Addendum No: One (01)

Project: Sedalia Downtown Streetscape Phase IV

Project No. 2019-03

Date: June 27, 2019

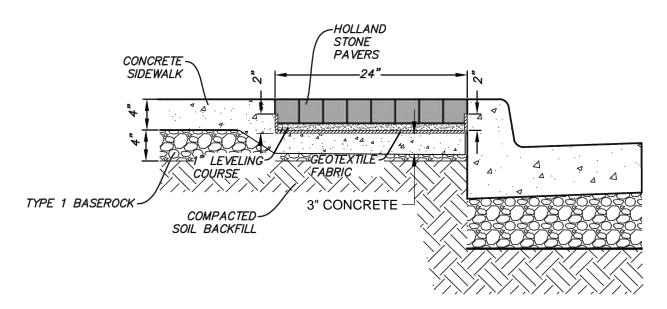
- 3. **DELETE** Detail G5 on **SHEET C-130** in its entirety and replace with the attached detail.
- 4. **CLARIFICATION SHEET C-132, Structural Steel Note 9:** An inspector is not required if the Contractor provides the structural steel fabricators proof of AISC certification and it is found adequate in meeting all AWS D1.1 code requirements.

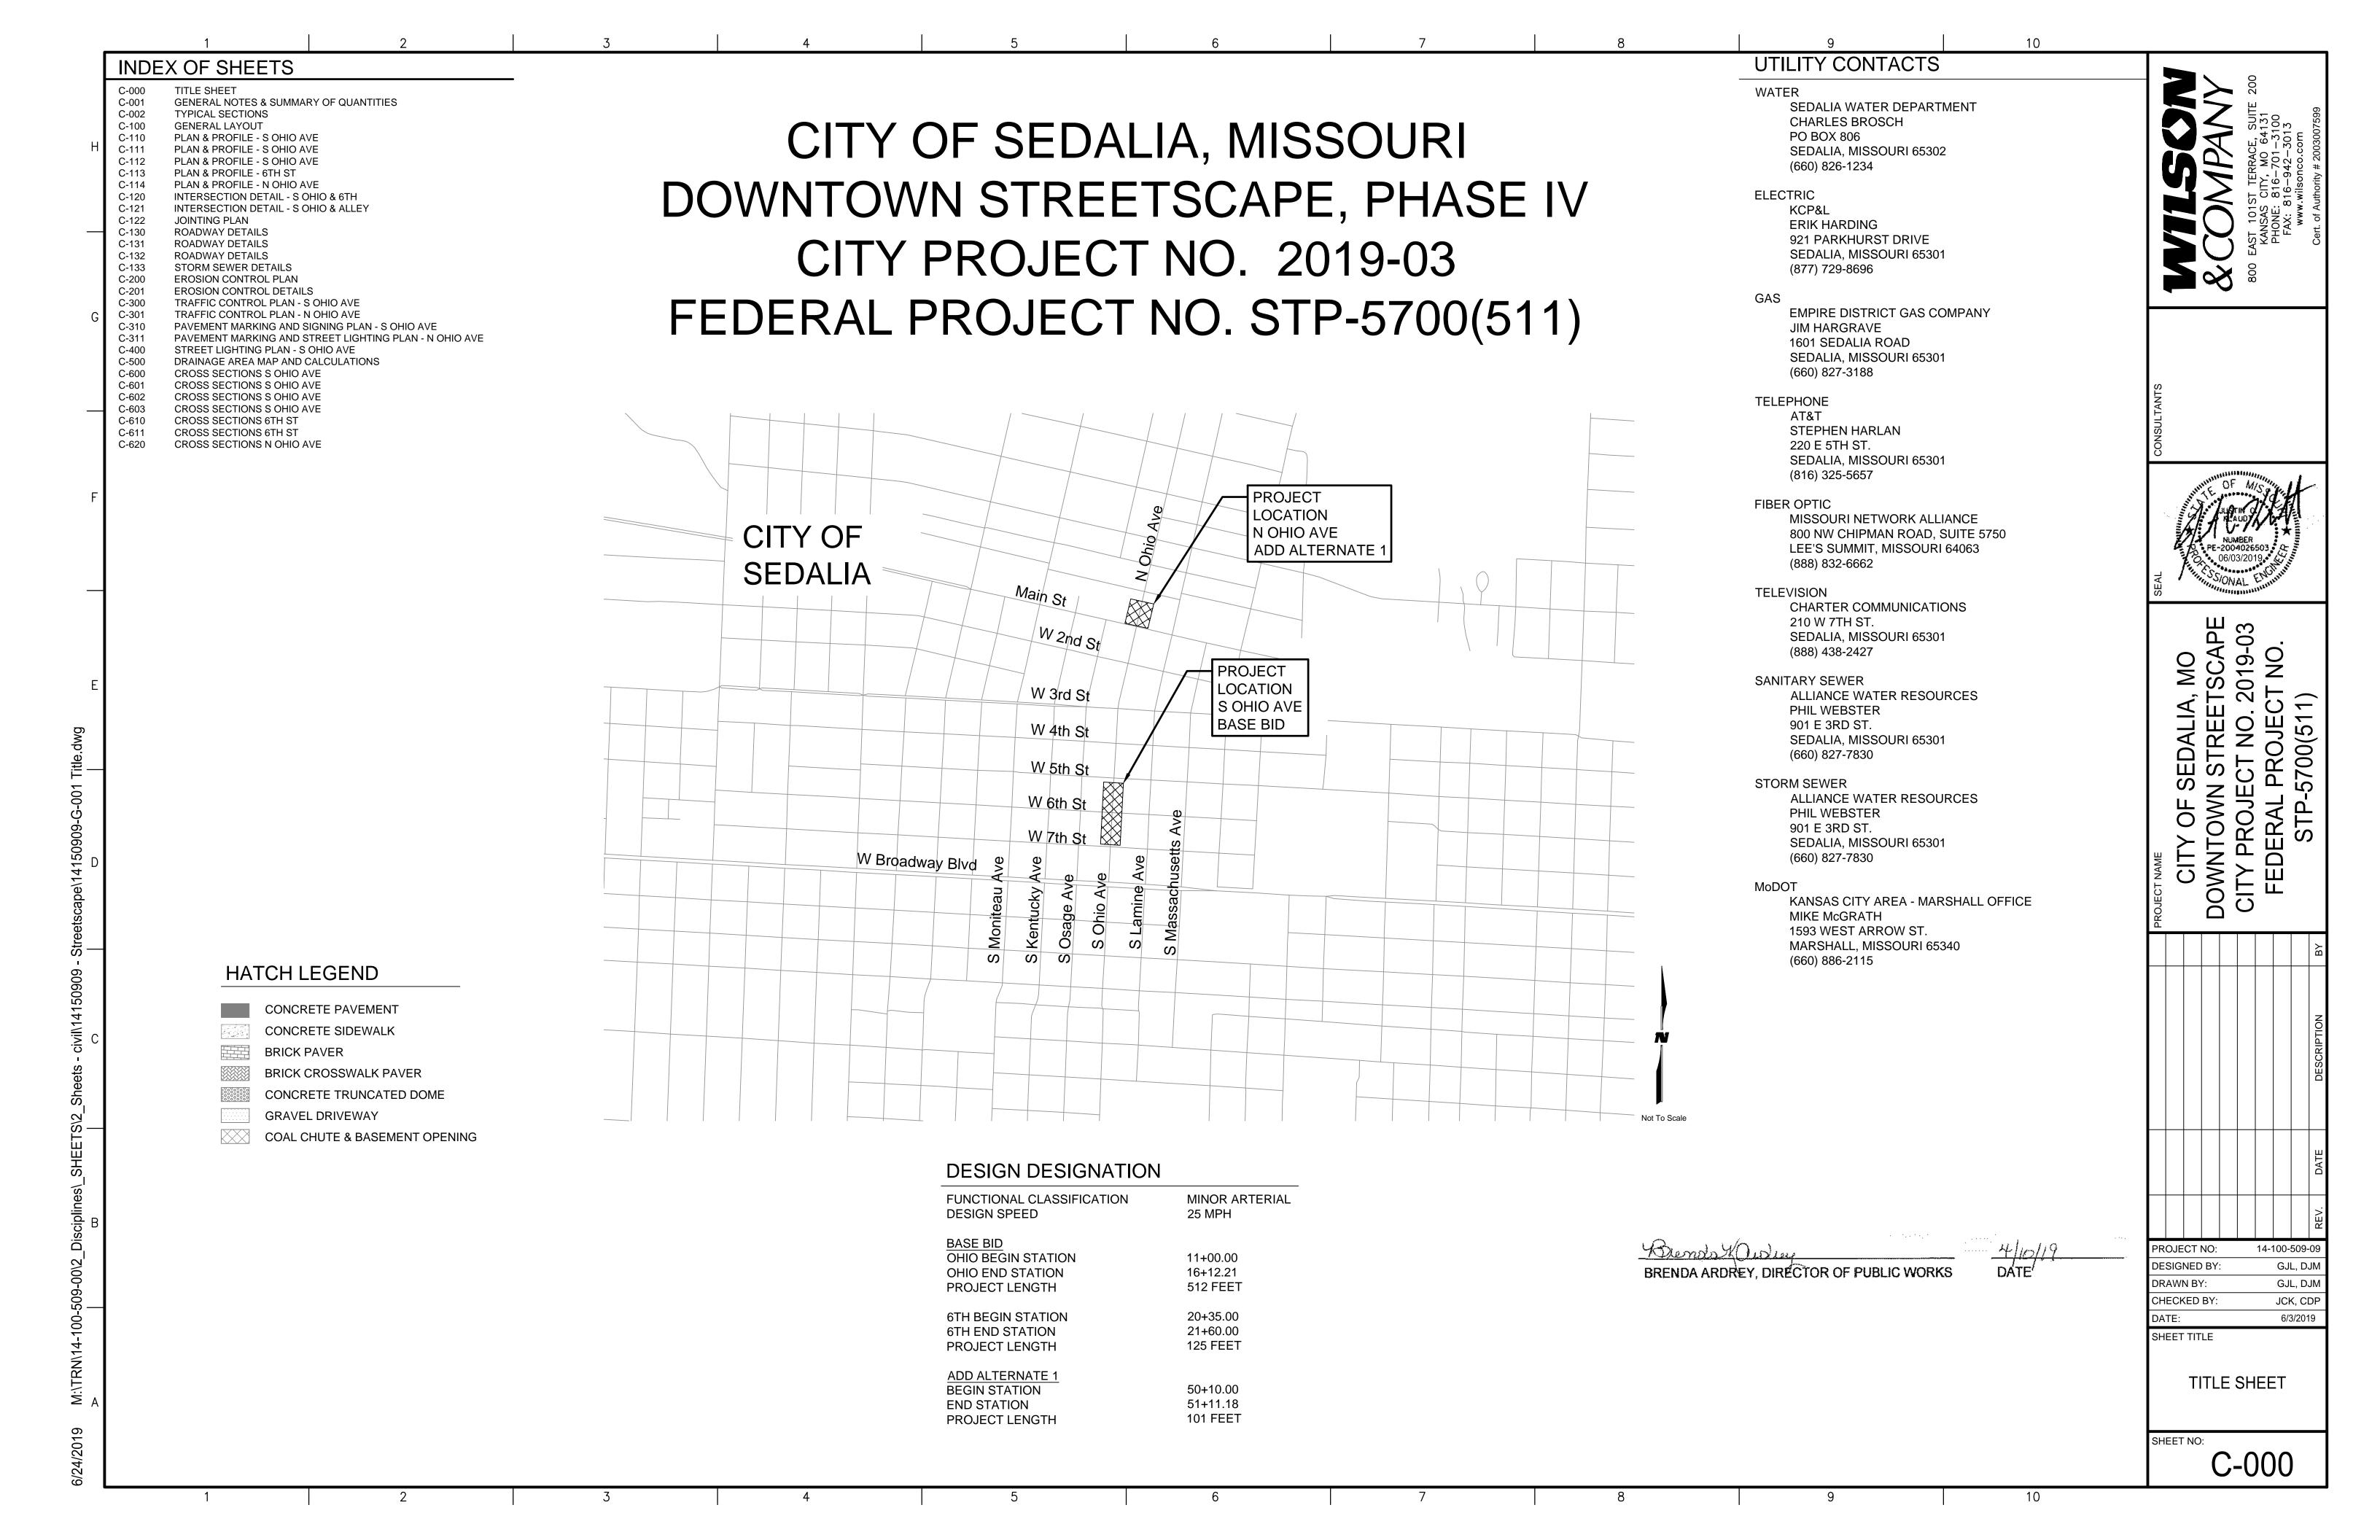
- e. C-400 STREET LIGHTING PLAN S. OHIO AVE.
 - Removed Decorative Metered Service Pedestal. Added Pole Base Detail and Notes.
- 8. **CLARIFICATION SHEET C-400** (Also applies to proposed Decorative Street Lights included in Add Alternate 1, N. Ohio Ave. SHEET C-311):

- a. KCP&L Provides and Installs:
 - i. Decorative Light Poles
 - ii. Conductors

- iii. Fixtures
- b. KCP&L Provides and Contractor Installs
 - i. Galvanized Anchor Bolts (This item considered subsidiary to work included with Bid Item, "Street Light Pole Base".
 - ii. Pull Box (Class 1)
- c. Contractor Provides and Installs:
 - i. Street Light Pole Bases
 - ii. 2" Sch. 40 PVC Conduit
 - iii. Pull String
